RE: 6th and Haines Redevelopment
Conceptual Grading and Drainage Plan
Stamp Date: 10/5/17
Hydrology File: H14D108

Based upon the information provided in your resubmittal received 10/5/17, the Conceptual Grading and Drainage Plan is approved for action by the DRB on the Site Plan for Building Permit and Site Plan for Subdivision.

SDP-3.2

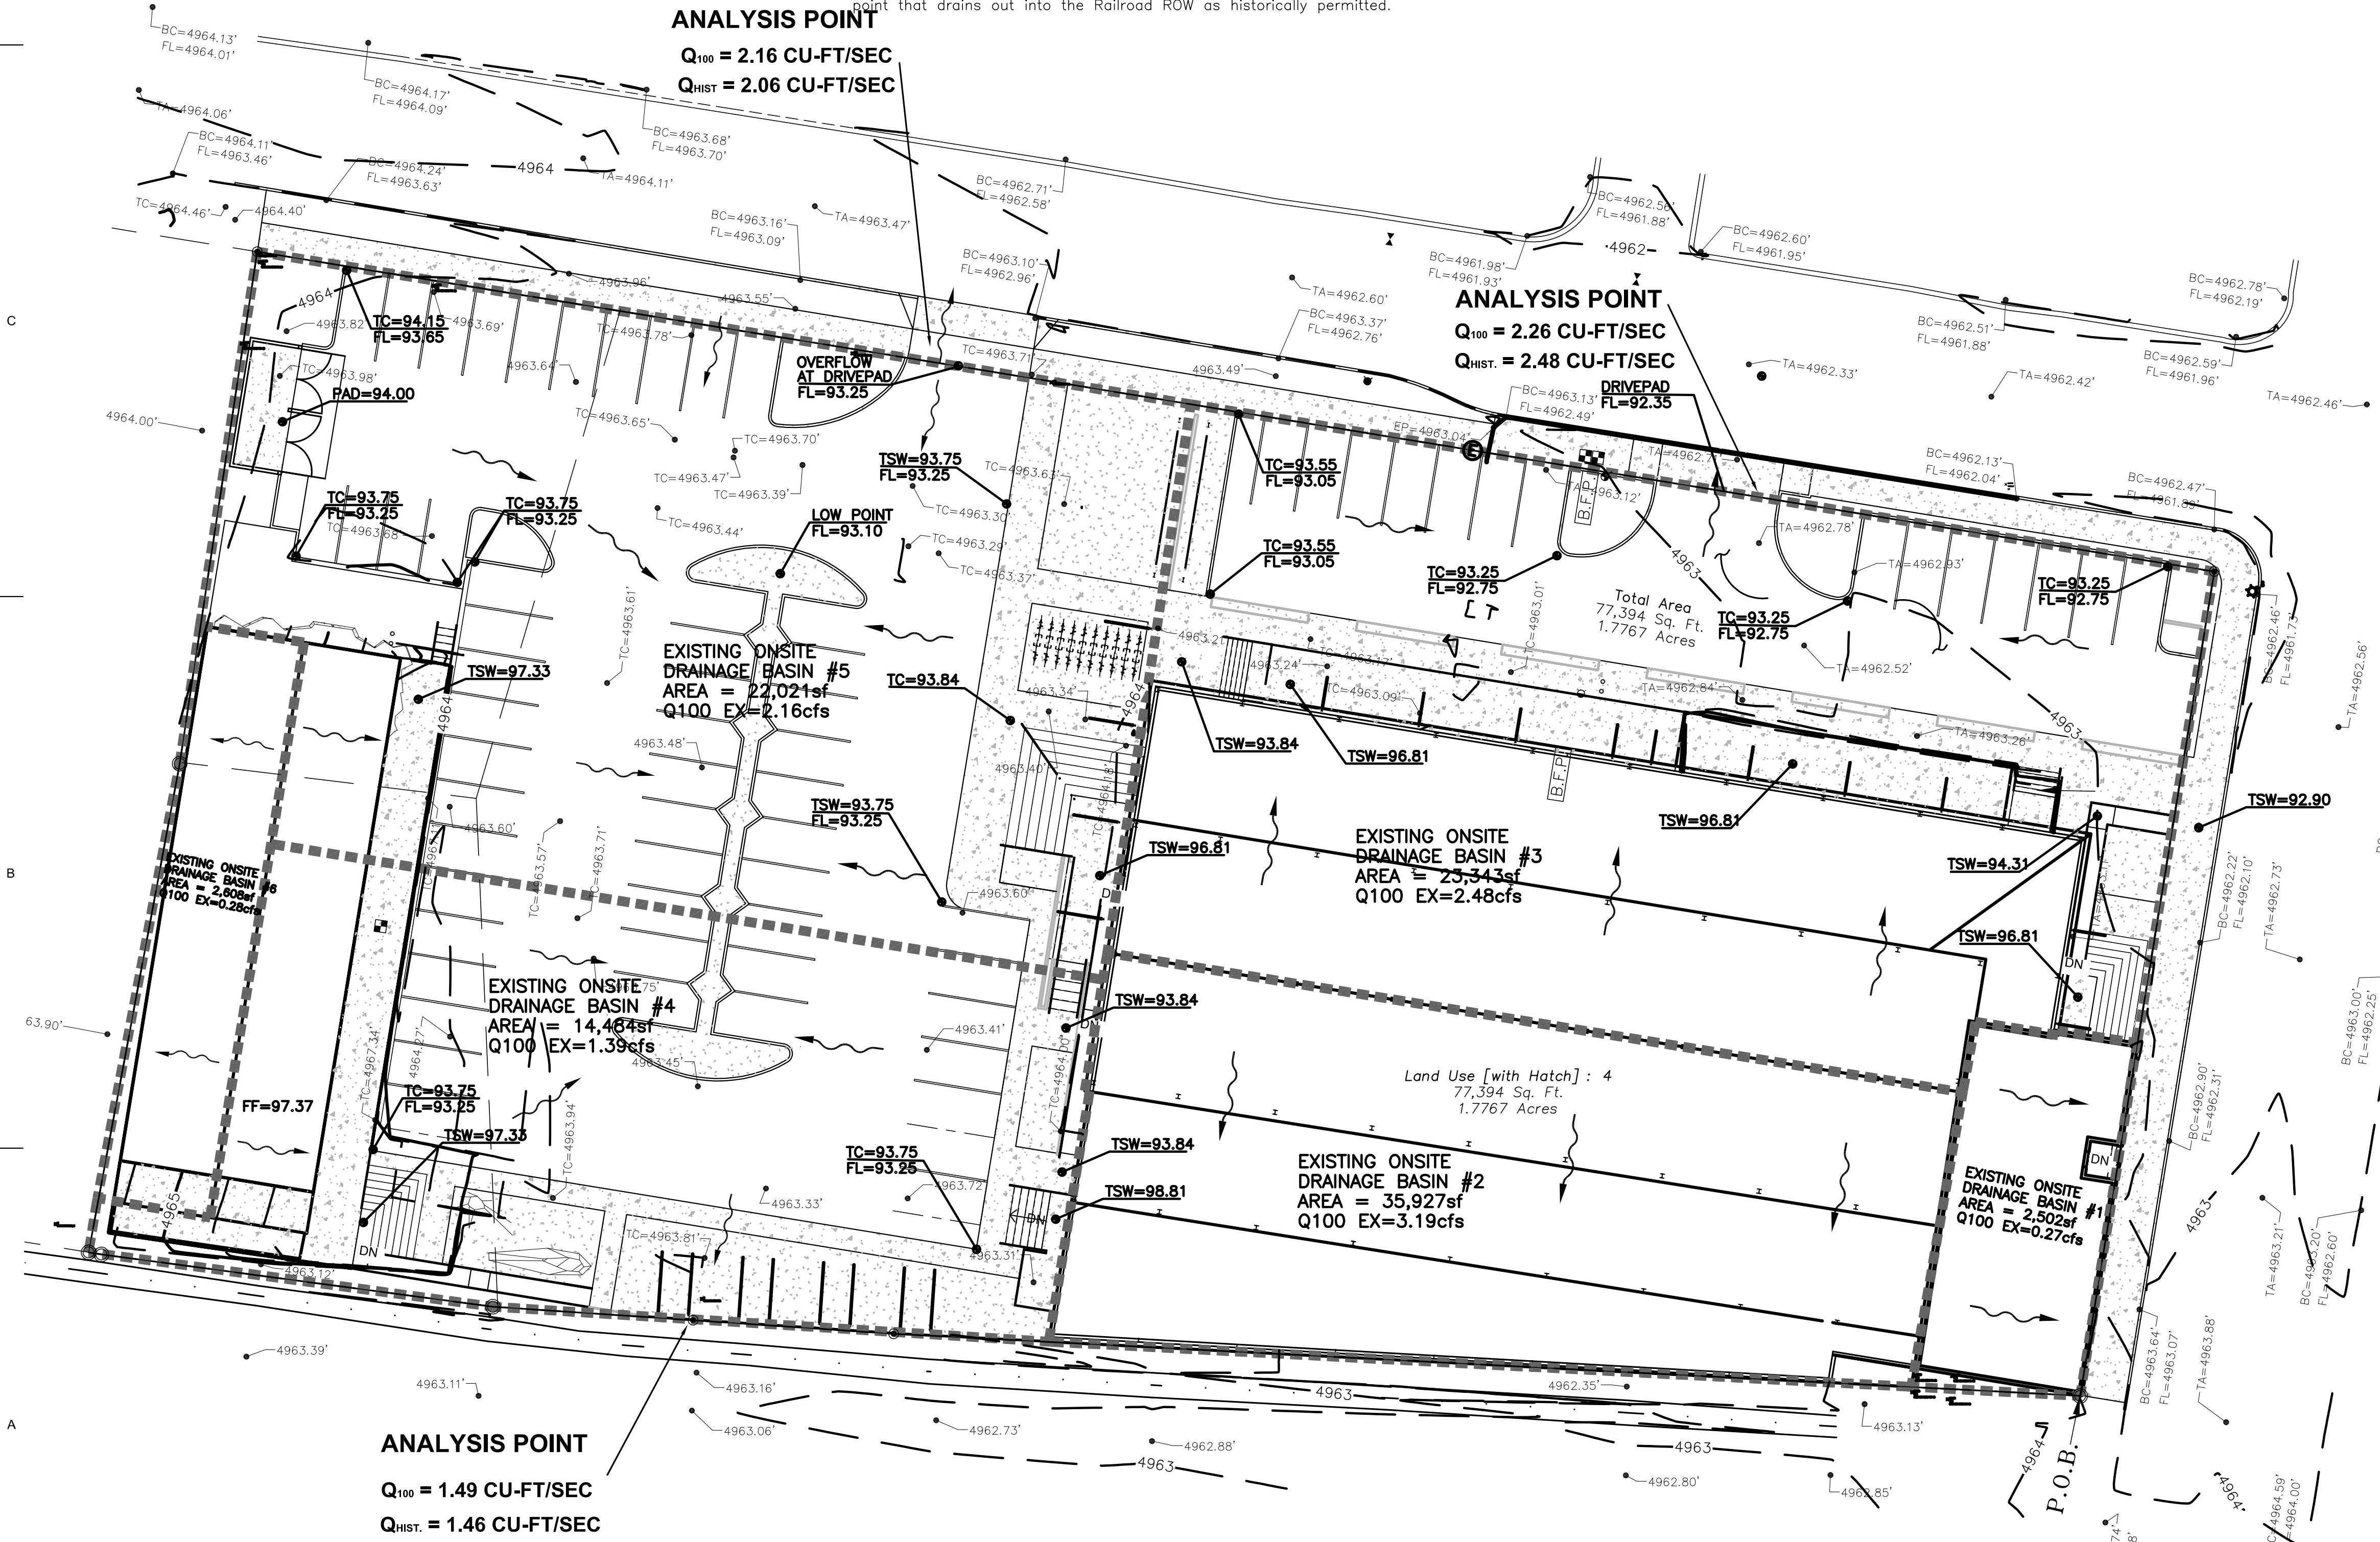
- On Sheets SDP-3.2, please call change the Basins to "Proposed" from "Existing".
- On Sheets SDP-3.2, please add the finished floor elevation to the main building.
- Please review the Proposed 100 year discharge. I checked Pro 4 and came up with 1.38 cfs instead of your 1.49 cfs.
- Not all basins need a first flush pond. Only Basin Pro 5 needs one since the impervious area increased.
- Please add a curb cut or cuts to allow runoff to enter the first flush pond within the depressed landscape areas.
- Please show the weir calculations for the proposed curb cut or cuts.
